**RE: Multi-Use Recreational Facility
Grading and Drainage Plan
Stamp Date: 10/30/17
Hydrology File: F16D003E1**

Based upon the information provided in your submittal received 11/07/2017, the Grading and Drainage Plan **is not** approved for Building Permit. The following comments need to be addressed for approval of the above referenced project:

DRAWN BY
JJG
DATE
10-30-17
2017035 CROSS
SECTIONS
SHEET #
C5
JOB #
2017035

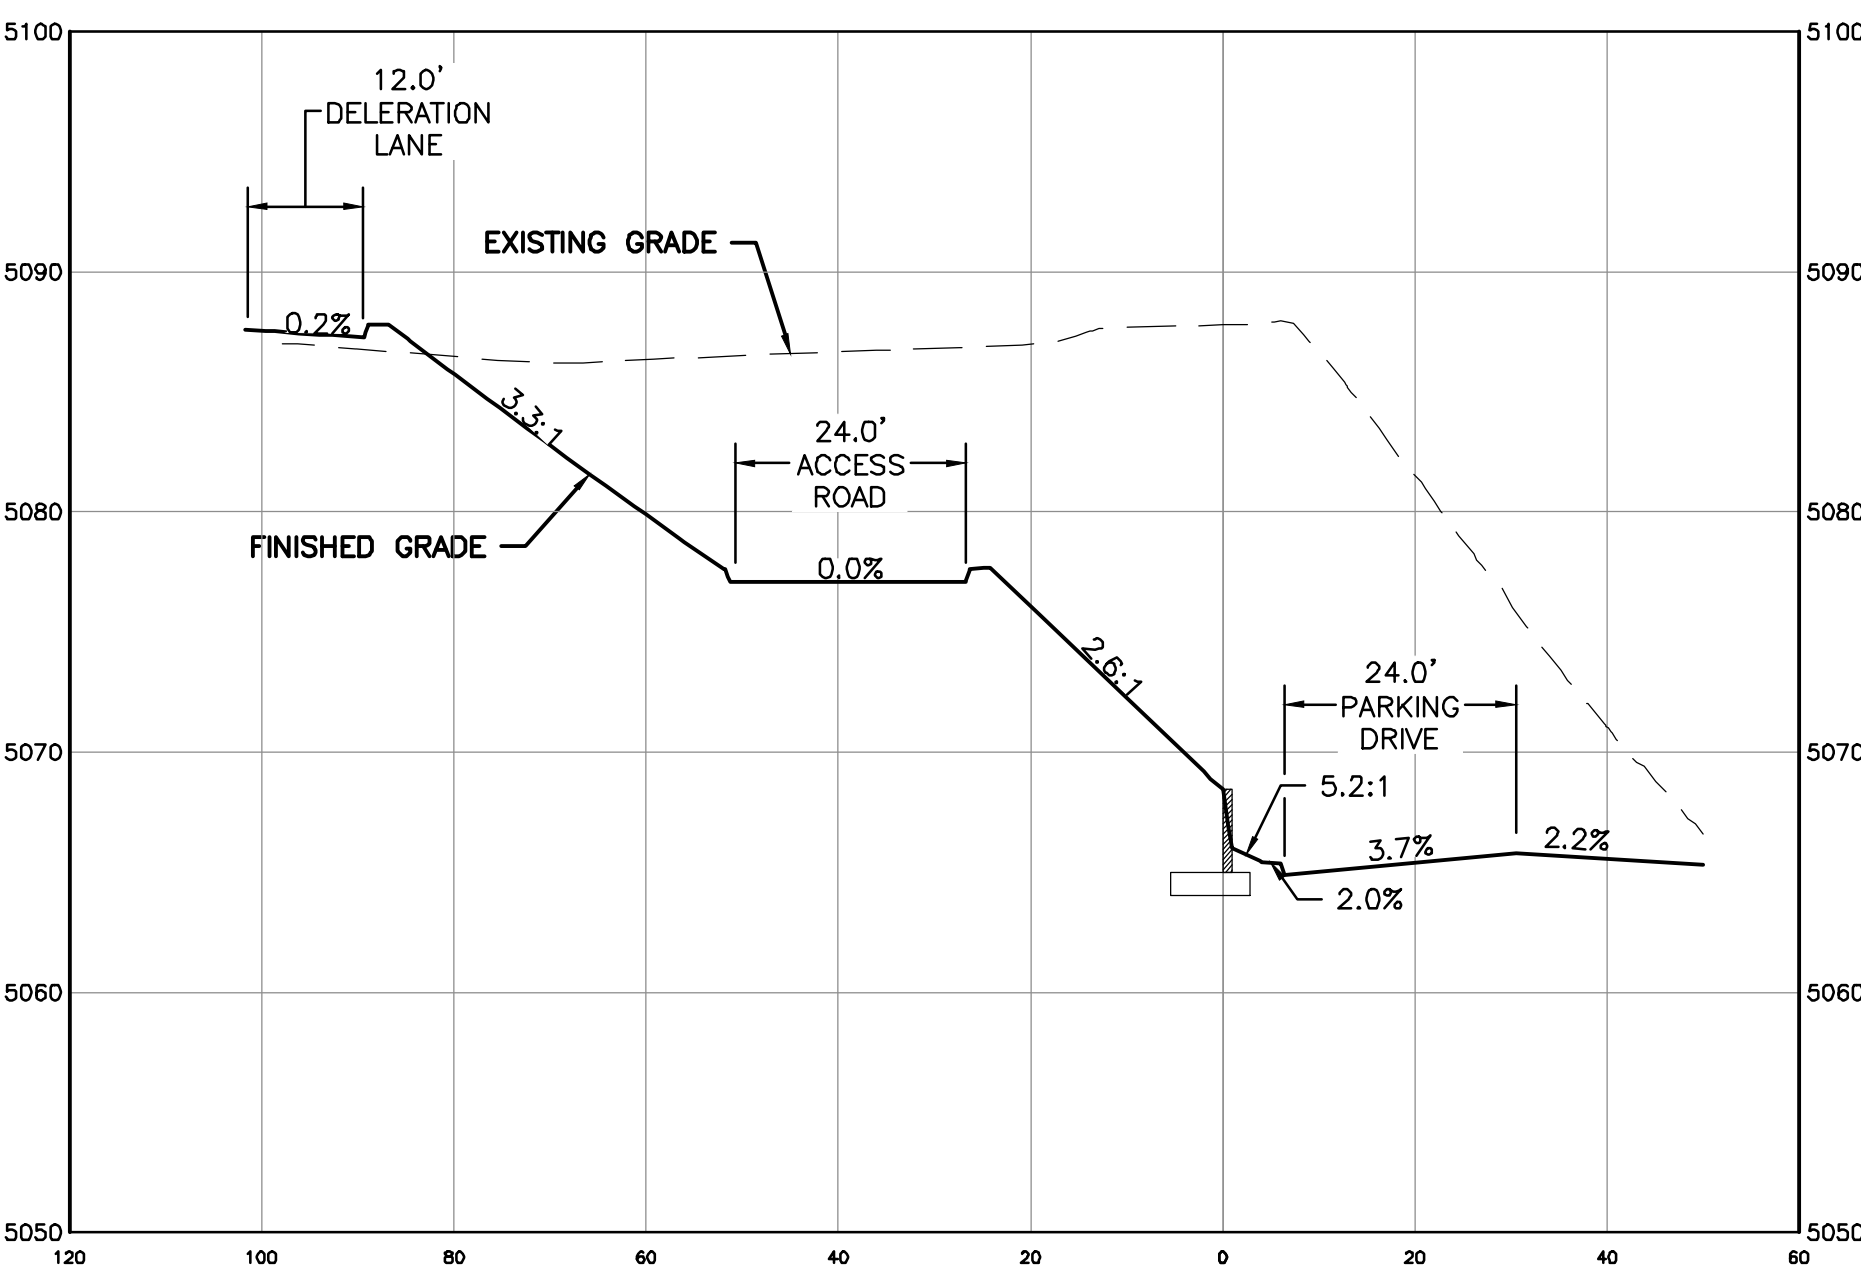
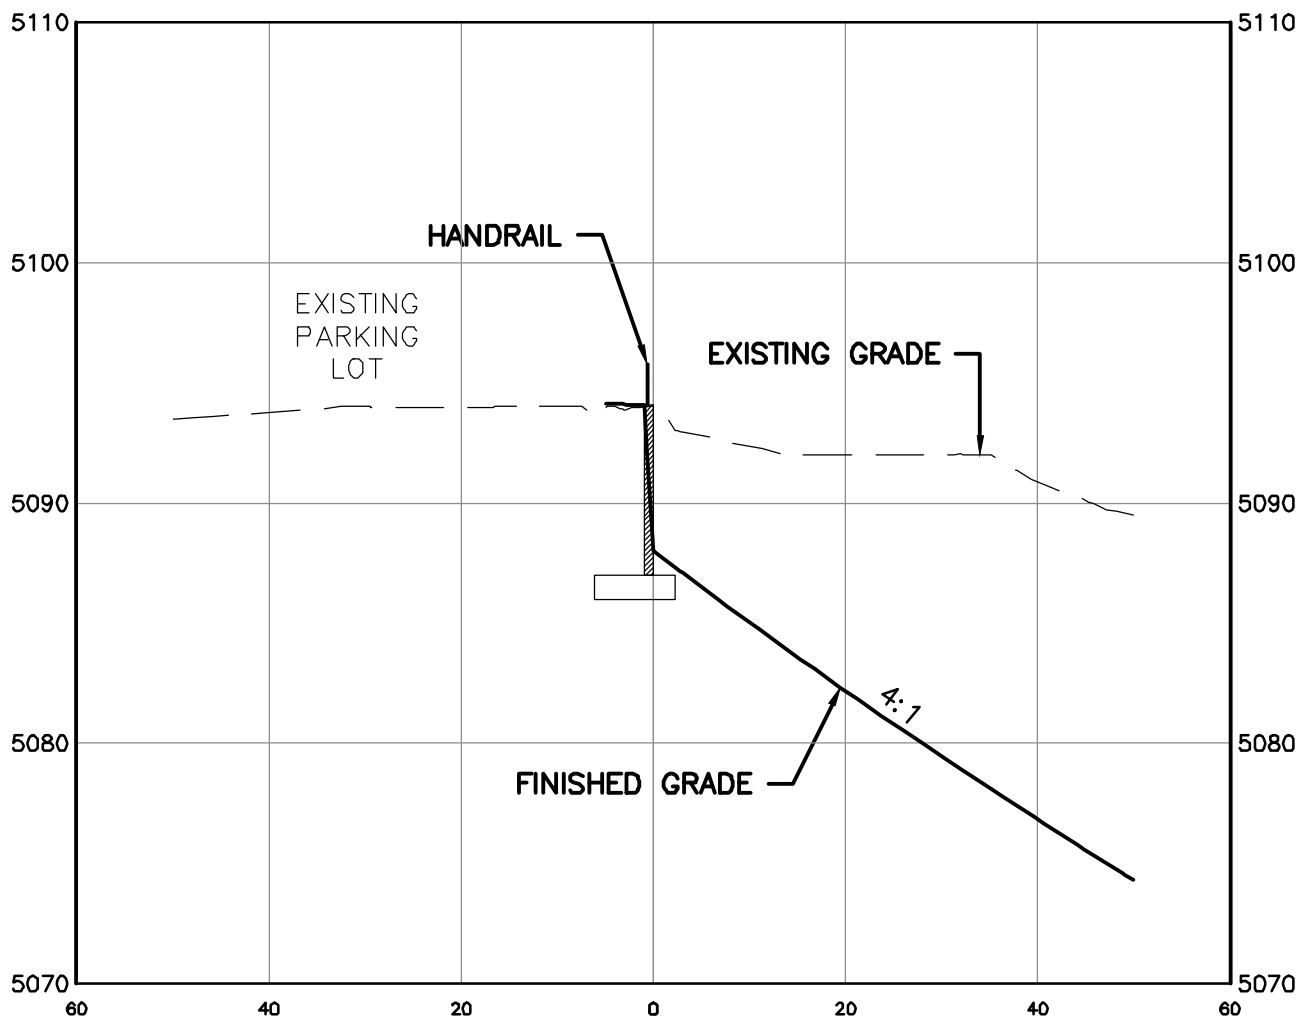
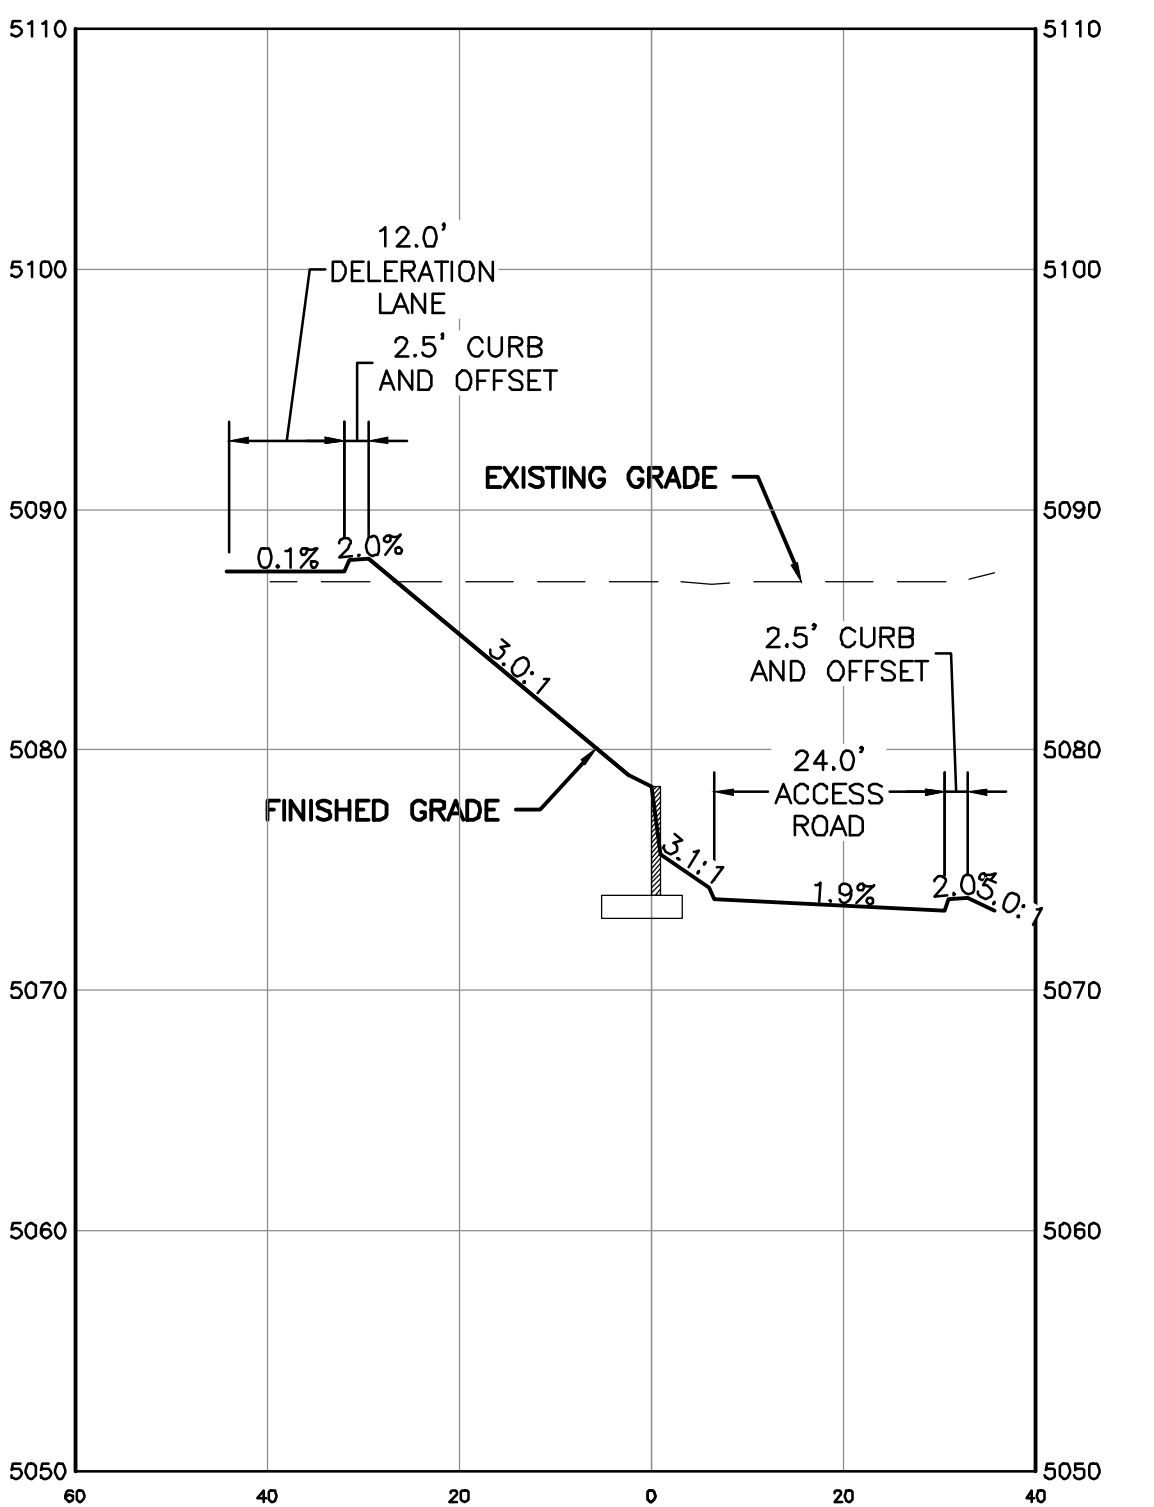
36. Sheet C5. Section D, E, & F. Please provide the property line and label either I-25 ROW or Lot A.
